82559 Fast Ethernet Multifunction PCI/CardBus Controller

Stepping Information

October 2004

Revision 2.2

6. Premature Clamping of Electrostatic Discharge Circuitry

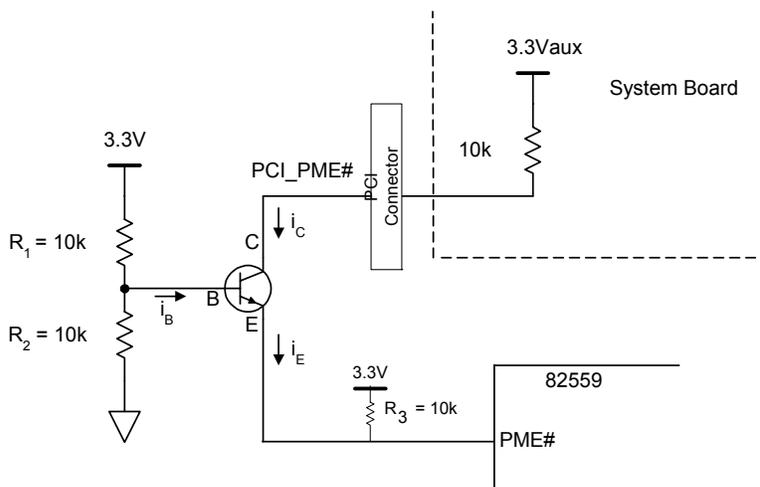
Problem: The Electrostatic Discharge (ESD) protection circuit of the 82559 B-step attempts to clamp bus signal levels when driven to a 5 V level. A direct diode connection to the 3.3 V power supply does not exist. Instead, the circuit configuration contains a 150 Ω resistor in series with the 82559's internal diode. This causes the clamping circuitry to limit the maximum signal level to four volts. Six specific signal pins (PCI signals Initialization Device Select, Reset, Clock, and Grant and device signals Alternate Reset and Isolate) are affected by this anomaly. This issue does not degrade AC timing or ESD protection.

Implication: This anomaly is limited to systems using a hard +5 V signal level on the PCI bus. When a +5 V level is applied to specific pins of the 82559 B-step, the protection circuitry engages. This causes the pins to sink additional current as the lines are held to approximately four volts. This

phenomenon is limited to six specific signal pins (PCI signals: Initialization Device Select, Reset, Clock, and Grant; device pins: Alternate Reset and Isolate). Currently, most platforms use 5 V tolerant 3.3 V devices to drive the PCI bus. The 82559 is one such device and does not draw any additional current into these pins. In legacy systems that use 5 V core devices (in other words, these signals are driven to 5 volts), the pins will draw additional current. This should not be a serious concern since all signals will still be maintained at valid logic levels and degradation in device longevity will not occur. Based on thorough analysis of this anomaly, there are no detrimental effects on system performance.

Workaround: In practical applications, no system changes are required for this anomaly. This is based on the understanding that the 82559 is normally driven by 3.3 V signals. In systems where +5 V devices may be driving the 82559, current limiting may be employed to protect the devices driving the 82559. Serial resistors may be added without any significant effect on signal quality.

Extensive testing of the 82559 with worst case current sinking has been performed. The results show that additional failures in seven years of constant operation should not occur due to this anomaly.

7. False Power Management Event Indication on Power Cycle

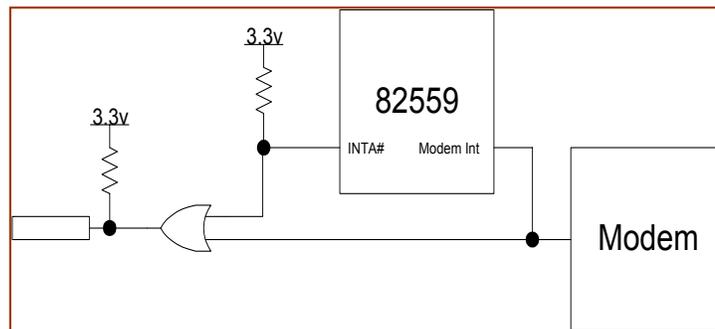
Problem: During power cycle events, the electrostatic discharge (ESD) elements internal to the 82559 may falsely clamp the Power Management Event (PME) output signal to approximately 1.5 volts for 100 ms to 150 ms during initial power up. This can cause wake-up events to be recognized by the system if power management events are enabled in the system chipset. This may result in a problem for mobile environments since the false clamping can cause a suspended system to wake up when the power to the LAN device is transitioned.

Implication: The implications of this anomaly depend on the target system configuration. In desktop and server systems, the impact is limited to a false wake-up event occurring when a new card is installed. In mobile systems where the LAN power is transitioned more frequently, the PME signal should be disabled during transitions.

Workaround: False PME indications can be avoided by disabling the recognition of a PME before removing or restoring power to the 82559. If a hardware solution is required, the following isolation circuit has been proven to be effective. The circuit requires the PCI PME signal (PCI_PME#) to be isolated from the 82559 PME signal (PME#). The system does not see the 1.5 voltage level drop caused by the 82559's power transition.

12. Potential Receive Overrun in Dynamic Standby Mode

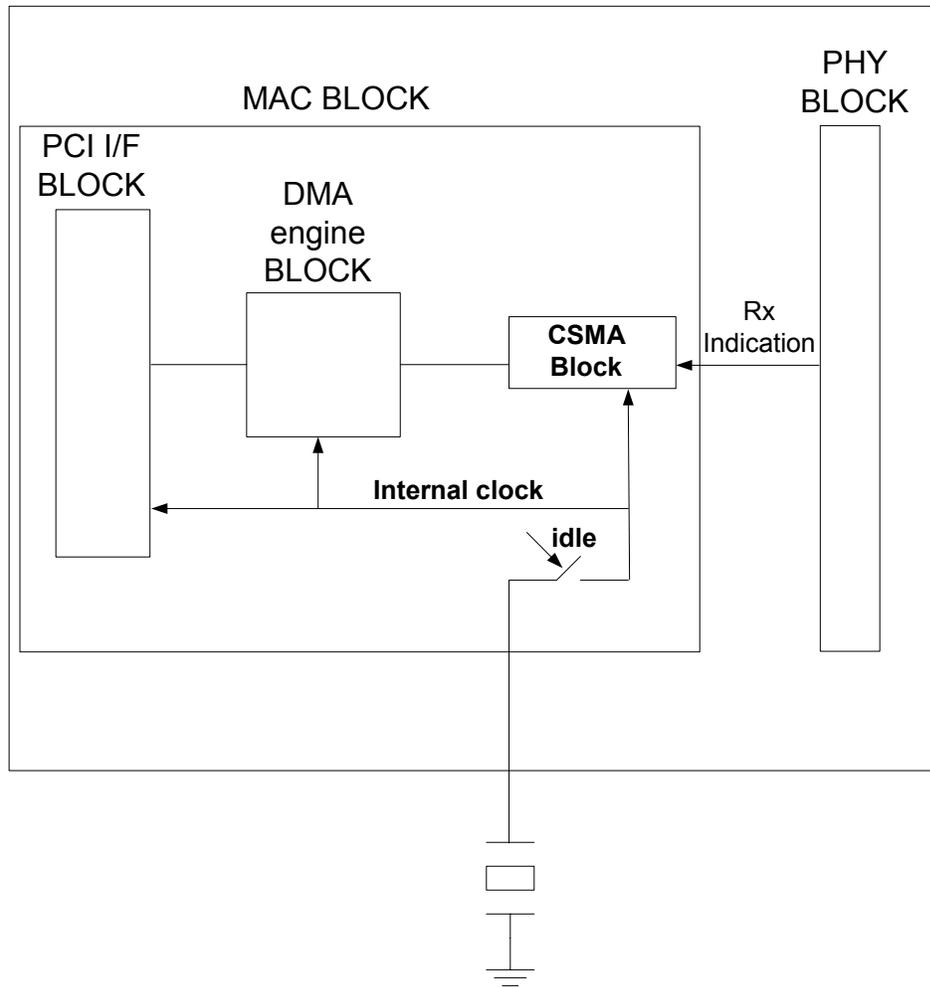
This issue can affect all design implementations using the 82559 (B-step) LAN Controller.

Problem: The 82559 (B-step) supports a Dynamic Standby mode. In this mode, the 82559 powers down certain logic blocks to save power during periods of inactivity. It automatically switches to Dynamic Standby Mode when it is in Idle mode and Dynamic Standby mode is enabled.

In Dynamic Standby mode, a possible synchronization condition may occur preventing the device from waking up when it receives an incoming frame. If this happens, the frame is not properly handled and is lost.

When the 82559 (B-step) is in the Dynamic Standby mode, clock signals to the MAC are stopped. Any received packet that passes address filtering causes the MAC block to wake up. The MAC block wakes up in a specific timing window by synchronizing between a recovered clock and

internal generated clock. A synchronization problem occurs between the recovered clock and internal generated clock. This window in which the problem can occur is identified as approximately 20 clocks at the beginning of the reception of a packet.

Workaround: To avoid potential receive overruns, the Standby Enable bit in the EEPROM (Word 0Ah, bit 1) should be set to 0b. This results in increased power consumption of approximately 40 mW. (A DOS-based utility is available through your local Intel sales representative to disable the Standby Enable bit in the EEPROM.)
